Noncompliant Weld Inspection Techniques

Line 114 Non Destructive Examination Final Report

Issue Date December 5, 2013

Figure 2 - Weld 270 Indication with measurement inset showing length of 0.157" (3.9mm)

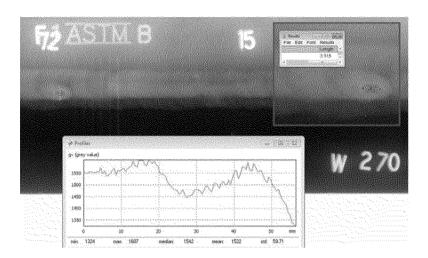
3.1 Weld 270, digitized in the region of interest is depicted in Figure 2. Here it can be seen, due to low change in density which is less than the adjacent parent material, and the presence of a halo, that the indication is one of Burn-Through (BT), and is acceptable per section 9.3.7 of API-1104. The weld repair process confirmed this result where the indication was found at the root.

Figure 3 – Weld 311 with acceptable BT length of 0.141" and acceptable small pores

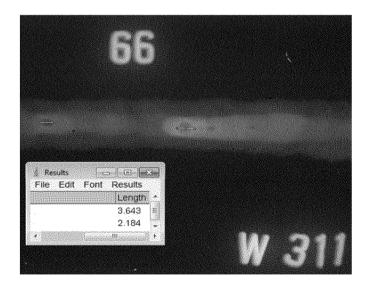
3.2 Weld 311, digitized in the region of interest, is depicted in Figure 3. Similarly we have one indication of burn-through and 3 small pores, all of which are acceptable per sections 9.3.7 & 9.3.9 of API 1104. For both welds 270 and 311, the repair process had to proceed to the root before the indications were eliminated, confirming that they were caused by burn through.

Figure 4 – Weld 162 with acceptable indications of undercut

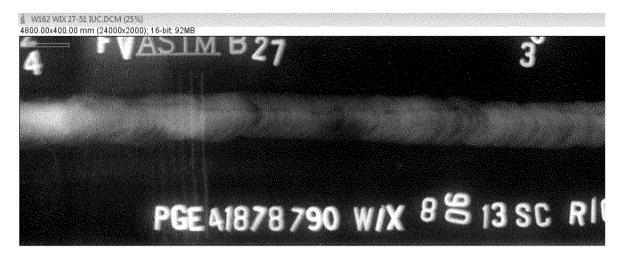
3.3 Weld 162 indication was digitized as shown below in Figure 4. Radiographic density measurements indicate that no portion of the indication has an indication of undercut which is greater than 0.016" deep, indicating that it is acceptable per section 9.3.11& 9.3.7 of API 1104.

Figure 5 - Measured IUC on W162 depicted in Figure 4

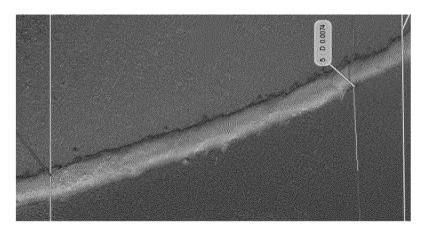
- 3.4 To validate the digital radiographic measurements, external visual, UC gaging and dial indicator measurements revealed that only small areas within the called ROI (25-29) had bottoms estimated below the adjacent parent material surface. Measurements had thus low repeatability due to topography. This result led to the decision for the Creaform photogrammetry with its calibrated 40 micron spatial resolution and accuracy to within 0.002".
- 3.5 Creaform photogrammetry results were obtained for the radiographic ROI (25-29 in Figure 4). The measurements confirm that no portion of the indicated area of concern radiographically, has a depth greater than 0.016 inches, and is therefore acceptable per sections 9.3.11 & 9.7. Figure 5 below depicts worst case of 0.0074" in radiographic ROI.

Figure 1 – Assessment of Weld 760 IUC region of interest

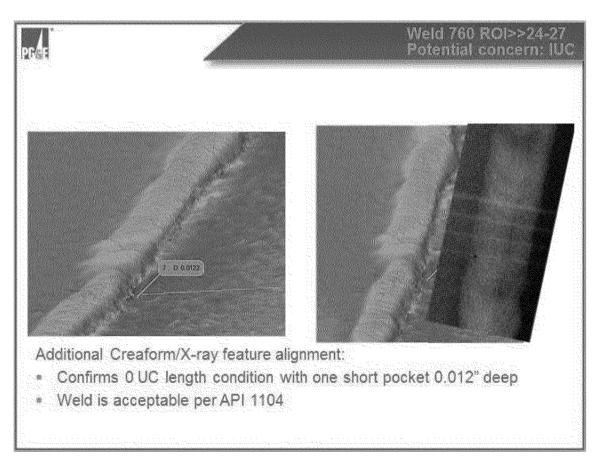
3.5 Creaform photogrammetry results were obtained for all the radiographic ROI's. The criteria applied to these results were API 1104 section 9.7, Table 4, "Maximum Dimensions of Undercutting". Applying the further criteria of depth from this requirement, to the documented radiographic and visual measurement data for length, all welds were found acceptable. Figure 2, from slide 5 in Appendix I, summarizes the typical physical condition for the audit identified indications of concern.

Weld 760 cited for indications of internal undercut from 24-27

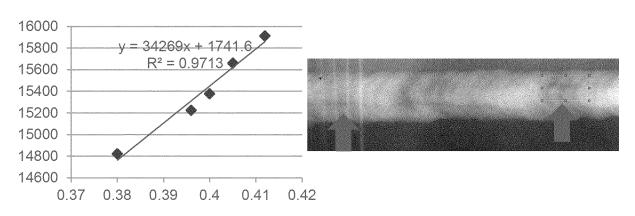
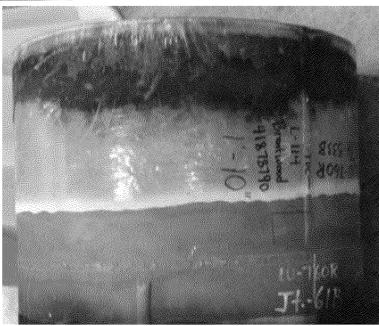
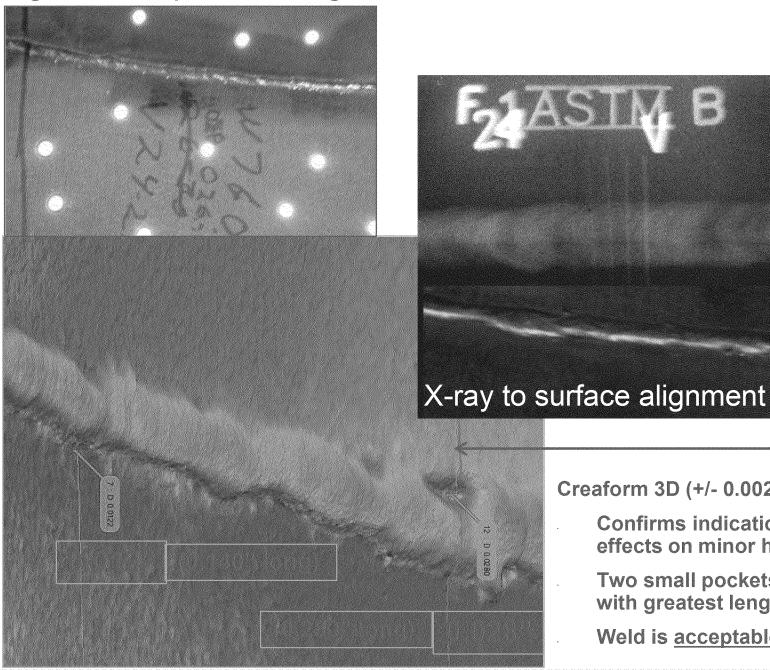
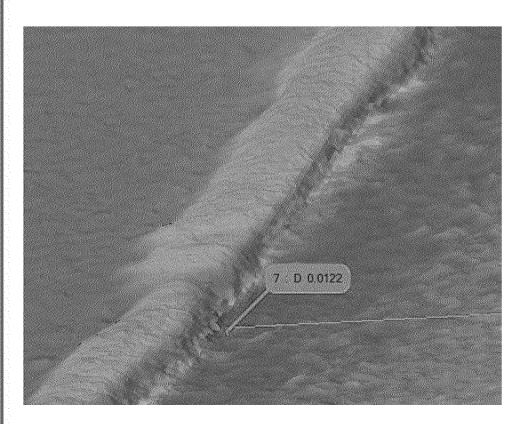
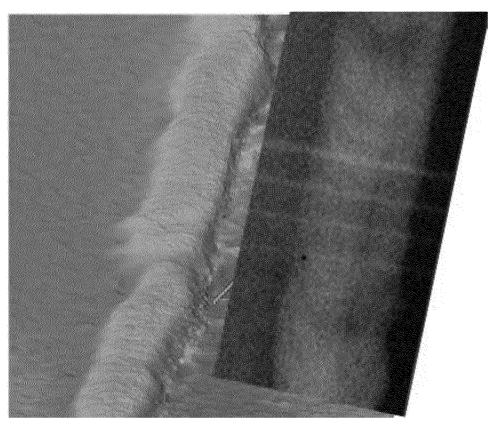
- **Confirms indications are mostly diffraction** effects on minor hi/lo condition with 0 UC
- Two small pockets are 12 and 28 mils deep with greatest length of 0.250"
- Weld is acceptable per API 1104

- * Confirms 0 UC length condition with one short pocket 0.012" deep
- * Weld is acceptable per API 1104

Weld 770 cited for indications of internal undercut from 36-42 Excised weld photo-documented and ROI aligned with weld features Depth of most severe indications estimated by change in x-ray density

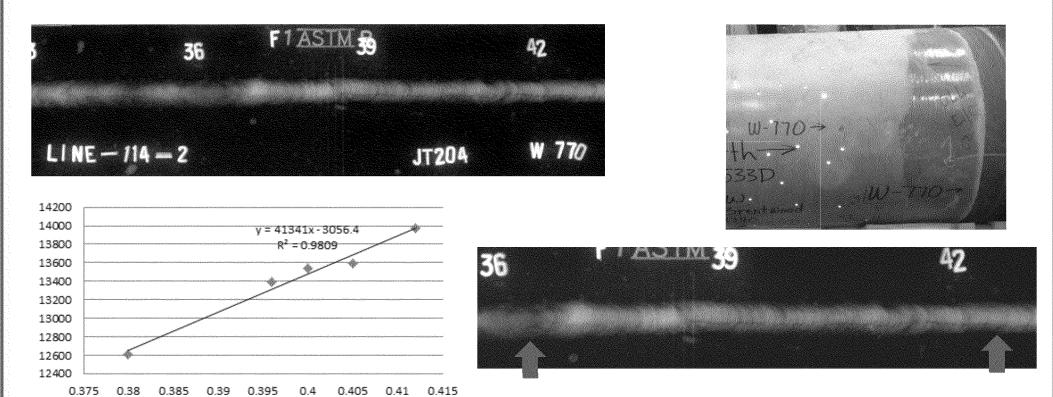
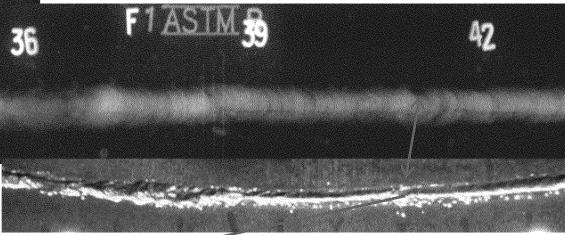
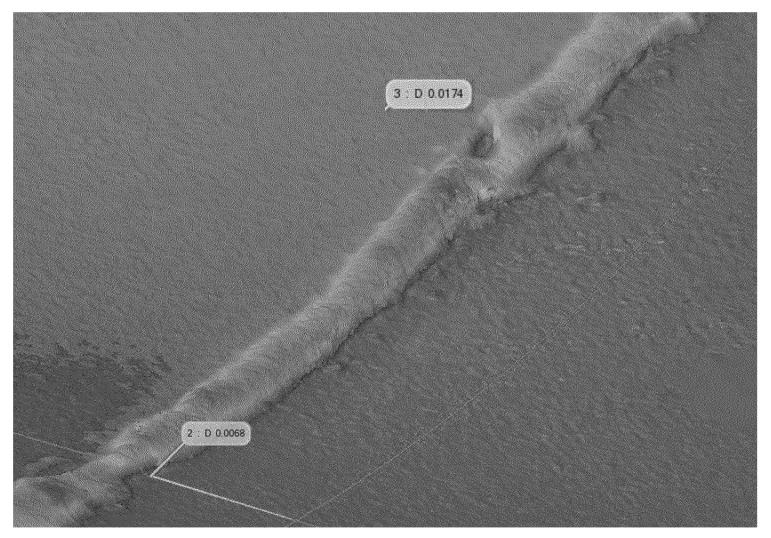
RT <u>estimated</u> depths of up to 0.008 inches Further correlation pursued with 3D surface map

- Confirms indications are, in the majority, diffraction effects on minor hi/lo condition with 0 UC
- One small pocket observed at 0.007" deep x 0.130" long
 - One unrelated pocket opposite ROI of 0.017" deep x 0.195" long
 - Weld is acceptable per API 1104

Weld 771 cited for indications of internal undercut from 12-24

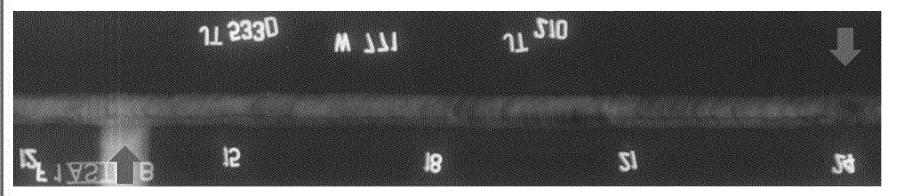
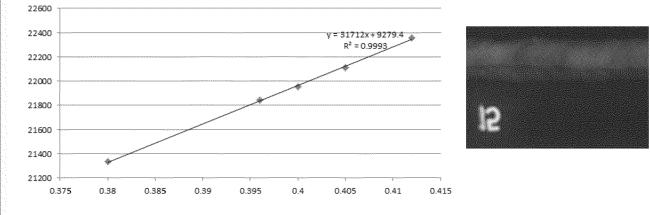
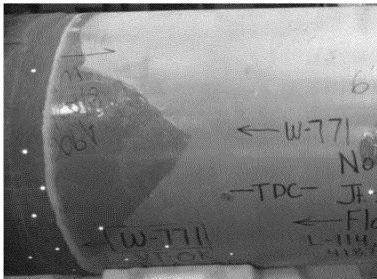
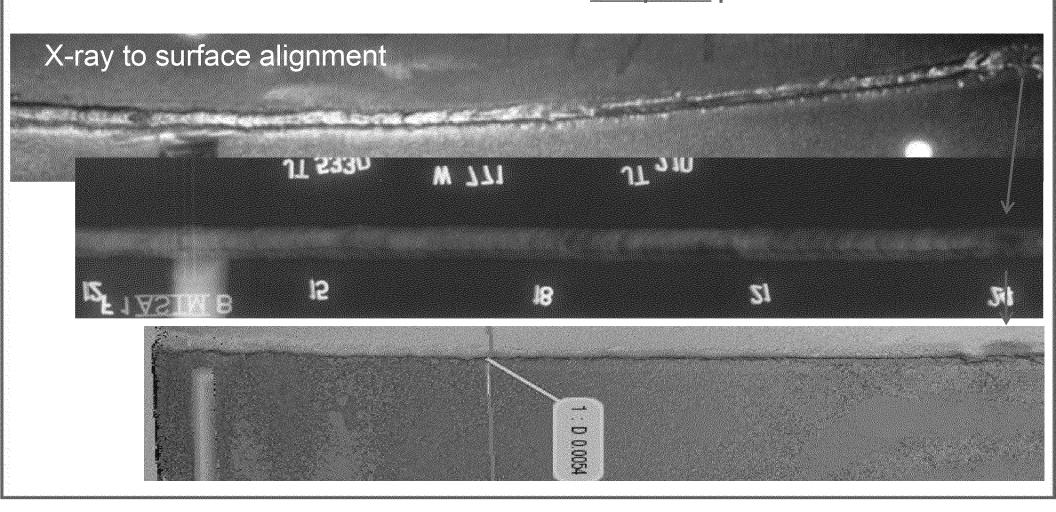
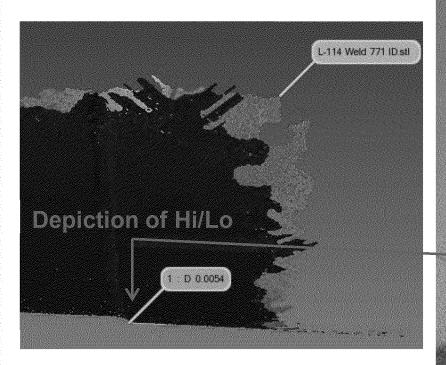
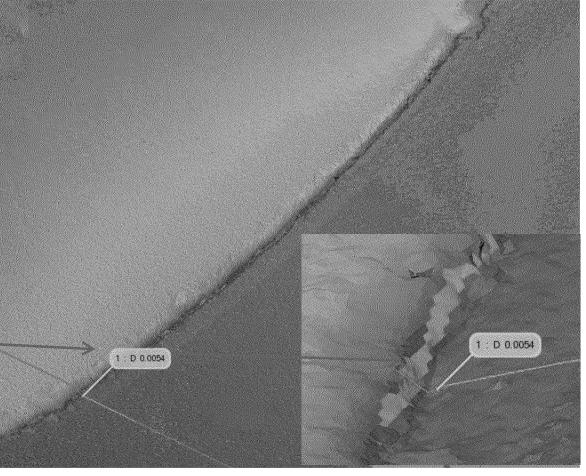
Confirms indications are mostly diffraction effects on minor hi/lo condition with 0 UC

Deepest region along length is 0.006 inches

- * Confirms UC indication is diffraction/"shadowing" from high/low condition
- * Weld is acceptable per API 1104

Weld 781 cited for indications of internal undercut from 44-49

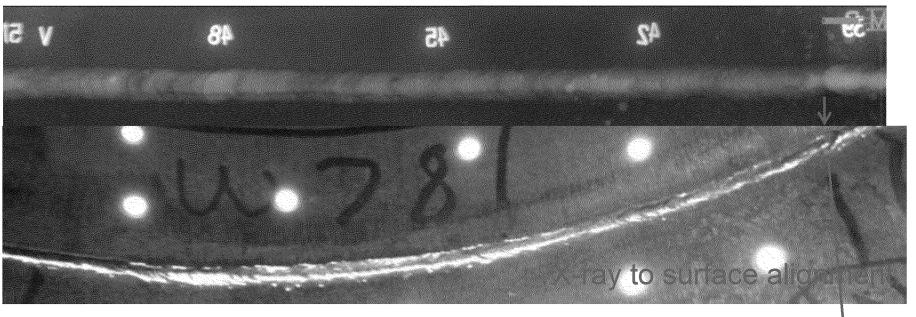
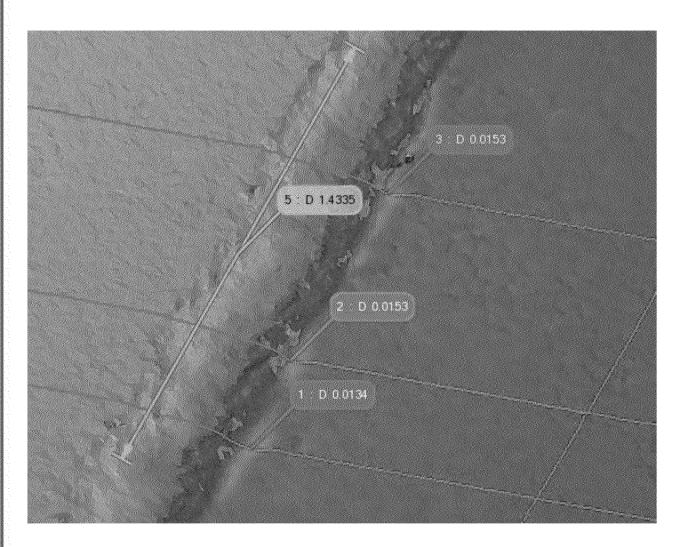
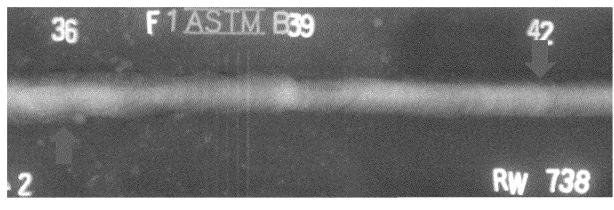
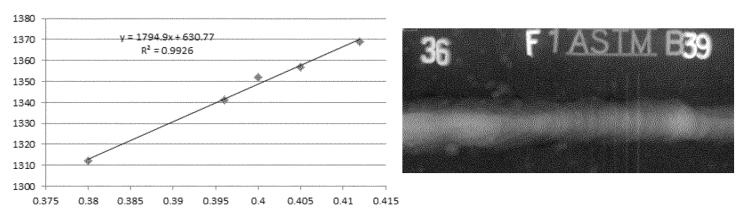
- Confirms indications are mostly diffraction effects on minor hi/lo condition with 0 UC
- Largest region is 1.5 long x up to 0.015 inches deep
 - Weld is acceptable per API 1104

- * Confirms UC indication is, in the majority, diffraction/"shadowing" from high/low condition with less than 2 inches of up to 0.015 inches deep IUC
- * Weld is acceptable per API 1104

Weld 738 cited for indications of external undercut from 36-42

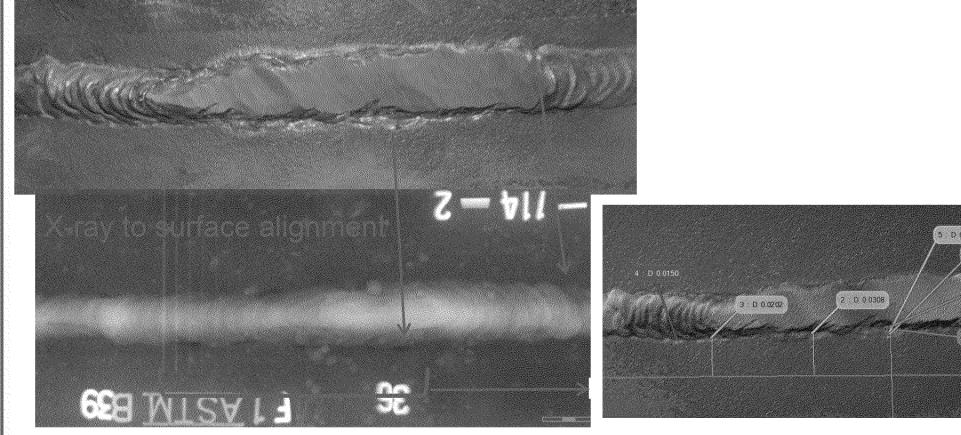
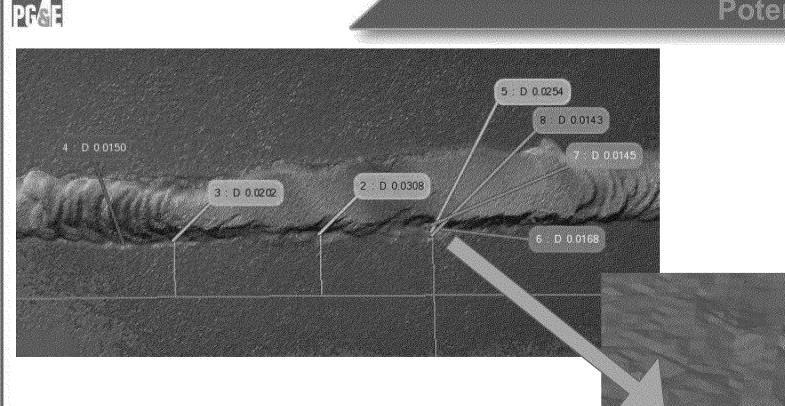
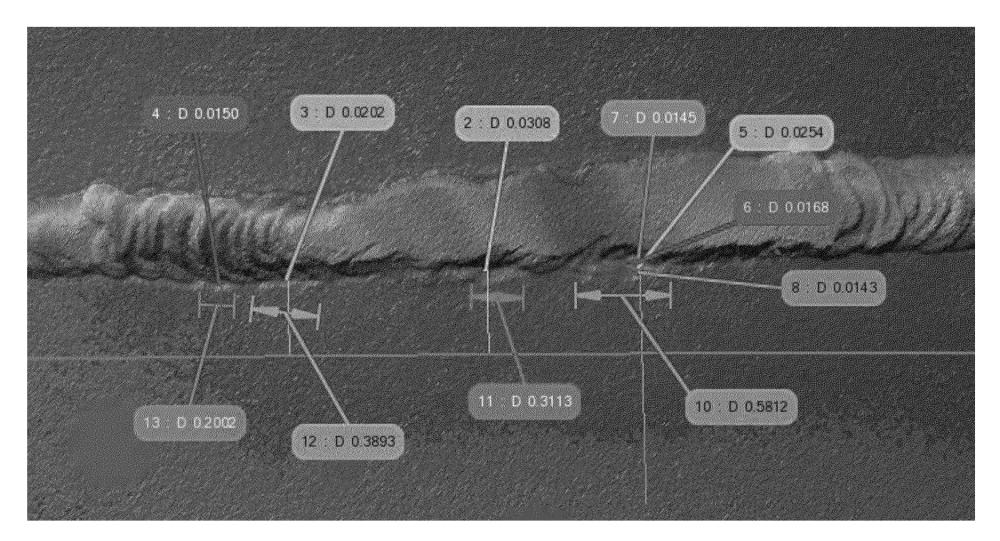
- External undercut identified up to 0.030" deep
- Sum of UC lengths < 1.5"
- Weld is acceptable per API 1104

- * EUC noted in several short segments totaling less than 1.5"
- * Weld is acceptable per API 1104
